Product Change Notification / SYST-23OUGH321

ERRATA - dsPIC33CH128MP508 Family Silicon Errata and Datasheet Clarification

dsPIC33CH128MP508 Family Silicon Errata and Data Sheet Clarification

FIGURE 1: I/O RAMP

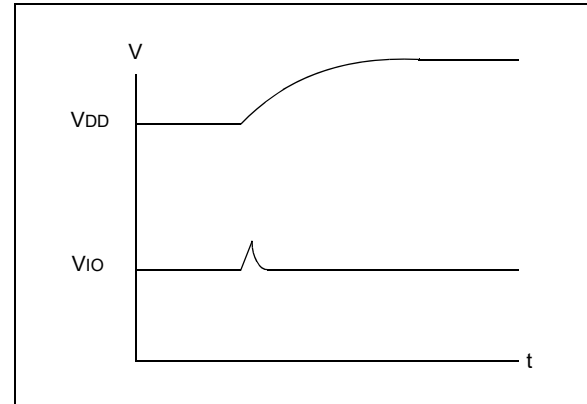
During a fast device power-up, when the V_{DD} ramp is less than 4 mS, the I/O pins may drive up to 100 μ A current for a duration of up to 10 μ S (Figure 1).

1. Slow down the V_{DD} ramp time (greater than 4 mS for V_{DD} to ramp 0V to 3.3V).
2. Ensure the circuitry that is connected to the pins can endure this pulse.

Example applications affected may include complementary power switches, where a transient current shoot-through might occur.

High-voltage applications with complementary switches should power the high-voltage 200 μ Sec later than powering the dsPIC[®] device to avoid the current shoot-through. This behavior is specific to each device and not affected by aging.

FIGURE 2-2: SUGGESTED PLACEMENT OF THE OSCILLATOR CIRCUIT

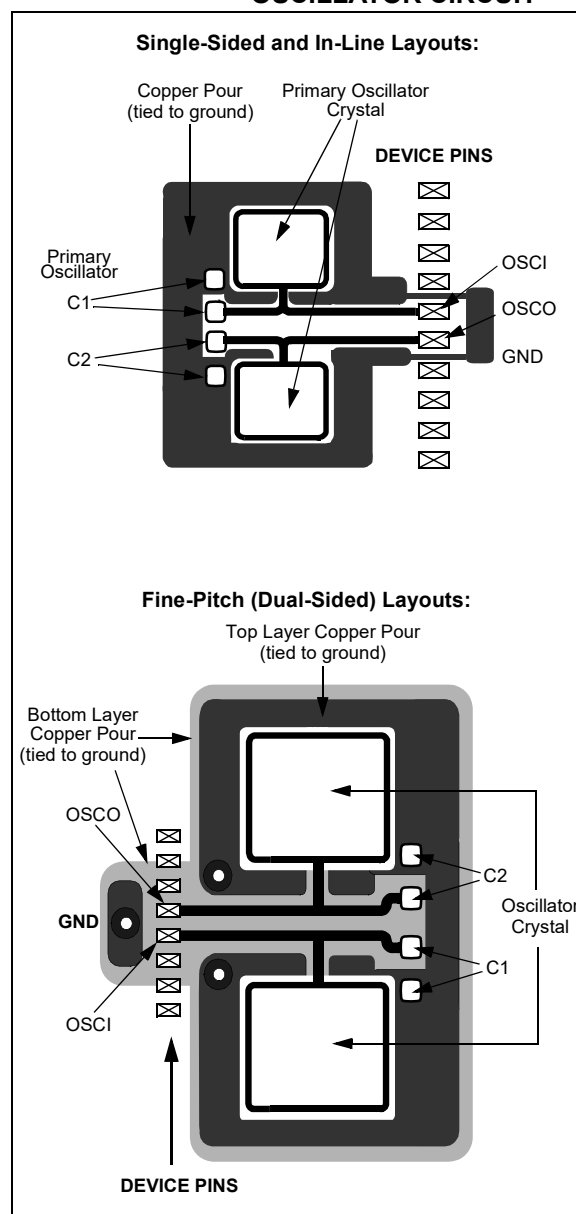
3. Module: Guidelines for Getting Started with 16-Bit Digital Signal Controllers

Additional information is added to [Section 2.5 “External Oscillator Pins”](#) and [Section 2.6 “External Oscillator Layout Guidance”](#) is added.

Use best practices during PCB layout to ensure robust start-up and operation. The oscillator circuit should be placed on the same side of the board as the device. Also, place the oscillator circuit close to the respective oscillator pins, not exceeding one-half inch (12 mm) distance between them. The load capacitors should be placed next to the oscillator itself, on the same side of the board. Use a grounded copper pour around the oscillator circuit to isolate it from surrounding circuits. The grounded copper pour should be routed directly to the MCU ground. Do not run any signal traces or power traces inside the ground pour. If using a two-sided board, avoid any traces on the other side of the board where the crystal is placed. Suggested layouts are shown in [Figure 2-2](#). With fine-pitch packages, it is not always possible to completely surround the pins and components. A suit-

able solution is to tie the broken guard sections to a mirrored ground layer. In all cases, the guard trace(s) must be returned to ground.
